HISTORIC AND DESIGN REVIEW COMMISSION

HDRC CASE NO: 2018-119
ADDRESS: 120 CEDAR ST
LEGAL DESCRIPTION: NCB 949 BLK SPT OF 3 LOT W 145 FT OF N 65 FT OF 3 OR A25
ZONING: MF-33, HS
CITY COUNCIL DIST.: 1
DISTRICT: King William Historic District
LANDMARK: Wolff, Abraham - House
APPLICANT: David Armendariz
OWNER: David Armendariz
TYPE OF WORK: Installation of solar panels
APPLICATION RECEIVED: March 02, 2018
60-DAY REVIEW: May 01, 2018
REQUEST:

The applicant is requesting a Certificate of Appropriateness for approval to install solar panels on the roof of the primary historic structure.

David Armendariz, 120 Cedar Street #1

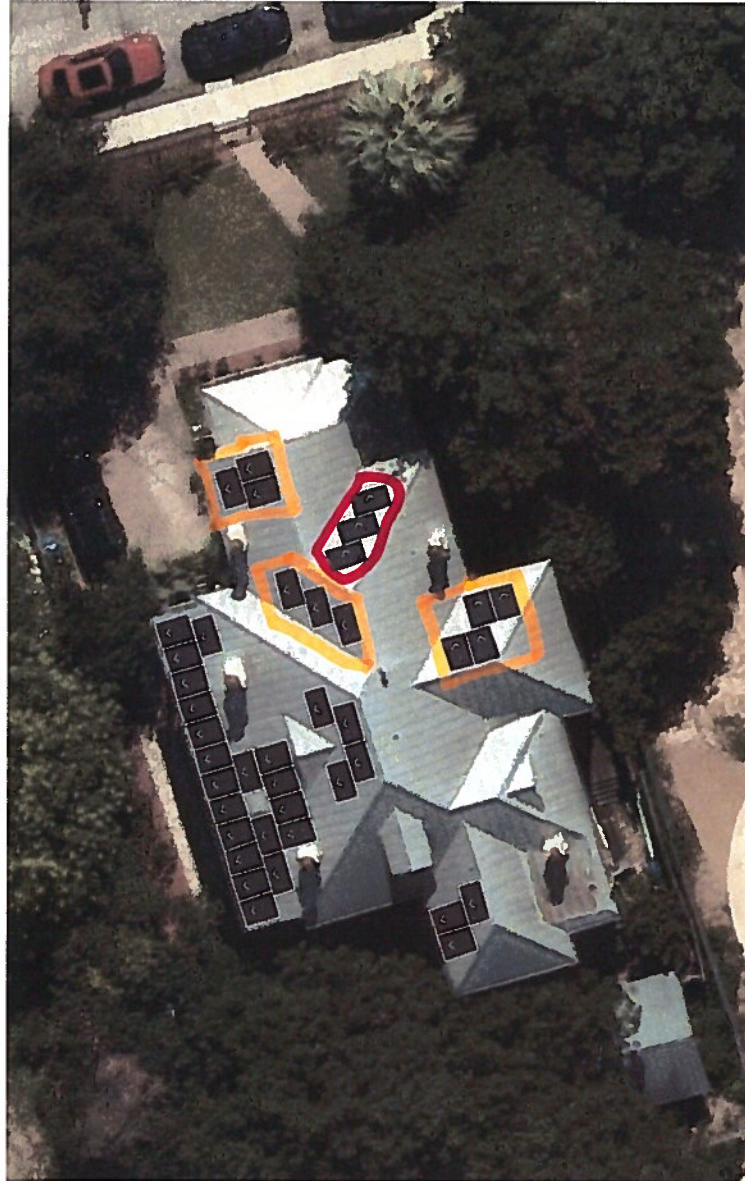
- b. LOCATION – The applicant has proposed to install forty (40) solar panels on the roof of the primary historic structure to be located on southern and western roof slopes. The applicant has proposed for the solar panels to be located in seven groupings. The Guidelines for Additions 6.C.i. notes that solar collectors should be located on the side or rear roof pitch of the primary historic structure to the maximum extent feasible to minimize visibility from the public right of way while maximizing solar access. Staff finds the proposed placement of many of the grouping to be appropriate; however, two groupings that include a total of seven solar panels are located on front facing roof slopes and two groupings will be located on prominent roof slopes located in a forward position on side roofs. Additionally, a grouping of four panels is located above a side facing dormer high on the southern roof slope.

- c. LOCATION – Staff finds that the two groupings that are located on front facing roof slopes, the two groupings that are located on prominent roof slopes located in a forward position on side roofs and the grouping of four panels that is located above the side dormer should be relocated toward the rear of the structure. Additionally, staff finds that the grouping should be arranged in a manner to limit the overall number of groupings.

- d. PITCH – The applicant has not specified a proposed pitch for the panels; however, staff finds that the panels should be mounted flush with the roof to be consistent with the Guidelines for Additions 6.C.ii.

- i. That the groupings noted in finding b that are located in forward positions on the southern roof slope, those that are located on front facing roof slopes and the grouping of four panels above the southern dormer should be relocated to positions toward the rear of the structure to reduce visibility from the public right of way. Additionally, staff recommends that the grouping be arranged in a manner to limit the overall number of groupings.
- ii. That the proposed panels be mounted flush with the existing roof slopes and feature mounting equipment that is comparable in color and finish to the roof.
